Foreseen as part of NA-CONS

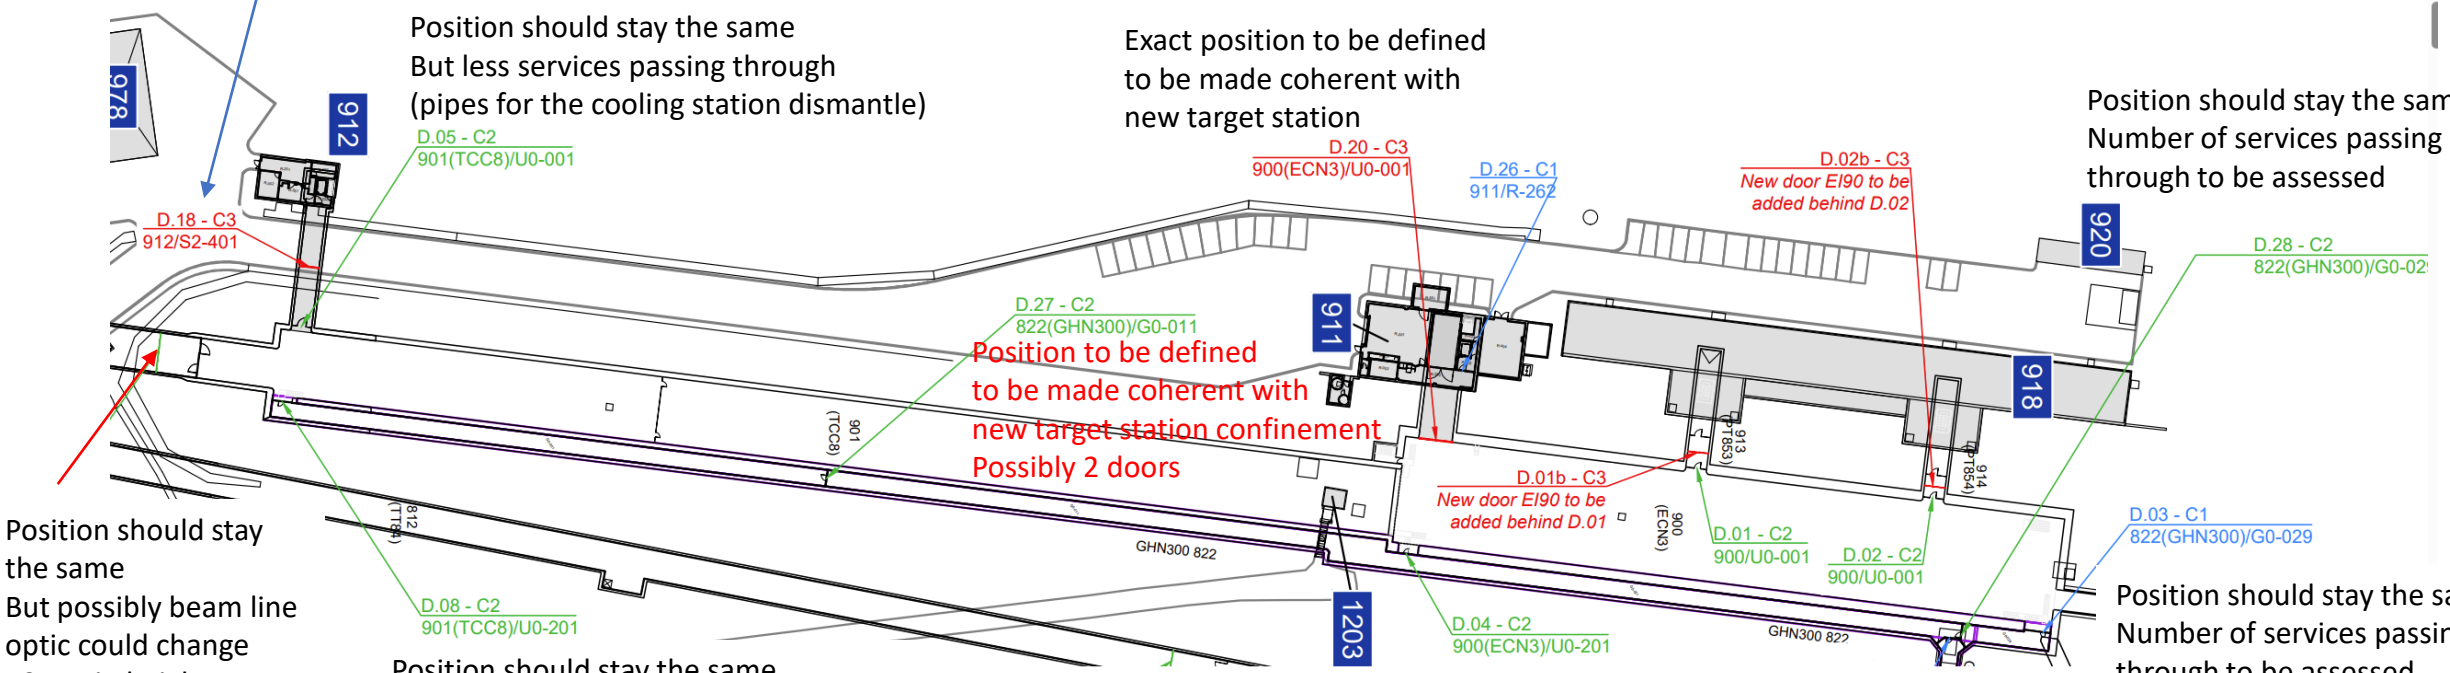
Motivation of this second door?
Location to be defined as per installation
of TCC8 crane control cubicles in the access tunnel

Position should stay the same
But possibly beam line optic could change +0,5m in height

Position should stay the same
But less services passing through
(pipes for the cooling station dismantle)

Exact position to be defined
to be made coherent with
new target station

Position should stay the same
Number of services passing through to be assessed

Position should stay the same
Number of services passing through to be assessed

Position should stay the same
Number of services passing through to be assessed
